# Product Change Notification

## 111633 - 00

**Change Notification #:** 111633 - 00  
**Change Title:** Intel(R) Server Board S2600CO, Update BIOS/ME/BMC/FRUSDR firmware; Add eUSB Stand-off and Change onboard R2A25 part, Product Design  
**Date of Publication:** July 27, 2012

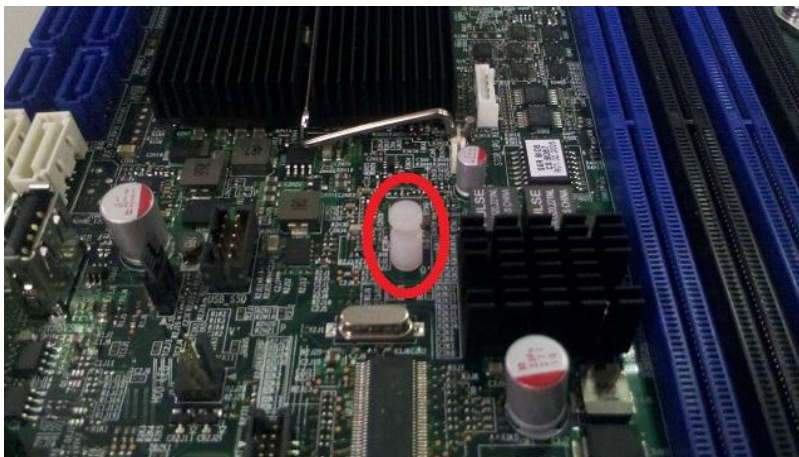
1. The BIOS is being upgraded to rev01.03.0002; The ME is being upgraded to rev02.01.05.107; The Integrated BMC Firmware is being upgraded to rev1.10.3560. The FRUSDR firmware is being upgraded to rev1.08. Please see BIOS/ME/Integrated BMC and FRUSDR release notes for more information.
2. Add the plastic stand-off depicted below to support an eUSB device on the server board:
